Contract #: 04-0120F4
 Cty: SF/ALA Rte: 80 PM: 13.2/13.9
 File #: 69.25B

QUALITY ASSURANCE -- NON-CONFORMANCE REPORT

Report No: NCR-000596

Welding	Concrete	Other	
Welding	Curing	Procedural	Bridge No: 34-0006
Joint fit-up	Coating	Other	Component: Cross beam 14 Floorbeam
Procedural	Procedural	Description:

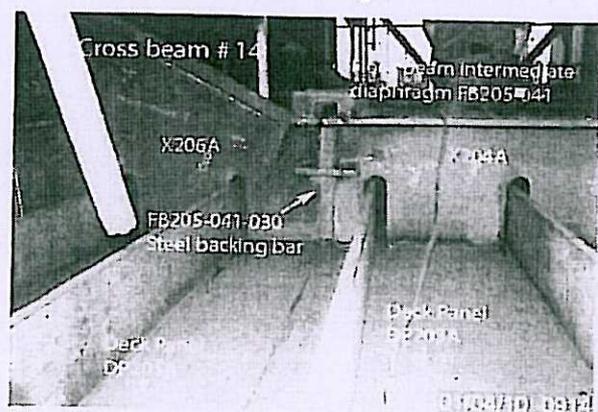
Reference Description: The welding of this floorbeam intermediate diaphragm joint has deviated from the approved joint detail in both the WPS and approved Welding Details

- The fabrication has deviated from the weld joint design specified on the approved drawings.
- The specified weld detail, WD60M, does not indicate the use of steel backing.
- Steel backing bar was added without approval of the Engineer.
- The measured root openings for these joints are between 7mm and 15mm.
- The WPS used for welding specified a maximum root gap of 6mm + 2mm.
- The weld joints affected are identified as: FB205-042-029, FB205-042-030, FB205-041-029, FB205-043-029, FB205-043-030, FB205-044-029, FB205-044-030, FB204-042-054, FB204-042-088, FB204-042-058, FB204-042-049, FB204-043-087, FB204-043-054, FB204-043-088, FB204-044-054, FB204-044-088, FB204-044-053, and FB204-044-087.
- The material is A709 Grade 345 Non Seismic Performance Critical Member (Non SPCM).
- OBG Cross beam CB14 is located in the Bay 3.-OBG Cross beam CB14 is located in the Bay 3.

Draft of welding discontinuity:

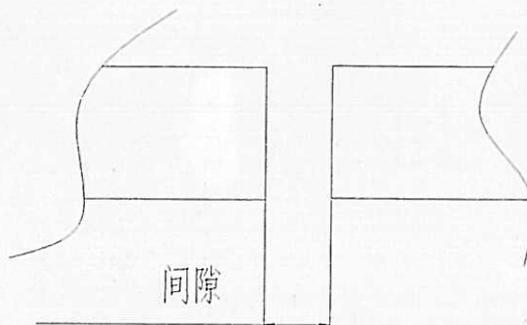
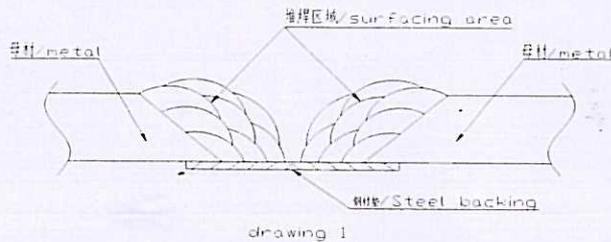
CB14隔板装配，对接缝间隙过大。相关情况如下：

Butt weld gap exceeded requirement during assembly CB14, the relevant size:

焊接变形和制作误差。

Weld distortion and fabricate error.

1. 将要修补的区域打磨光滑;
2. 准备一个正确的接头形式, 具体参见返修的WPS;
3. 做100%VT和100%MT, 并按照图一所示加钢衬垫;
4. 根据返修的焊接返修工艺规程(WPS)进行预热及焊接;
5. 焊后去除钢衬垫, 将焊缝打磨至与母材平齐;
6. 根据图纸要求进行相应的NDT(VT、MT和UT)检测;

1. Grind the edge of the repair area cleanly
2. Prepare an right joint according to the approved WPS;
3. Perform 100%VT and 100%MT, and add steel backing according to the attached drawing 1;
4. Preheat and weld according to the relevant WPS;
5. Gouge off the steel backing and grind the weld flush with base metal after welding;
6. Perform NDT inspection(VT, MT and UT) of the weld according to the working drawings.
